TECHNICAL SERVICE BULLETIN

492

Newmar changed the breaker box wiring and updated the SilverLeaf TM250 Load Management Module to help balance the electrical loads in 2018 New Aire Diesel Pusher coaches. Some coaches may have been shipped without the change being performed.

New Aire Breaker Box and TM250 Update

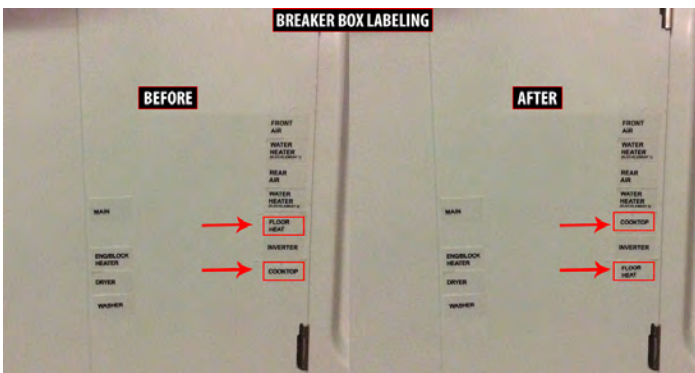
9. Remove the wire from the breaker marked floor heat.

10. Hook the wire up to the breaker marked "cooktop," and place the wire from the cooktop location into the breaker marked "floor heat."

Note: Do not flip the breaker positions to move the floor heat.

11. Remove the label marked "floor heat" and the label marked "cooktop" and swap their positions. If they do not stick well, use clear tape to adhere them.
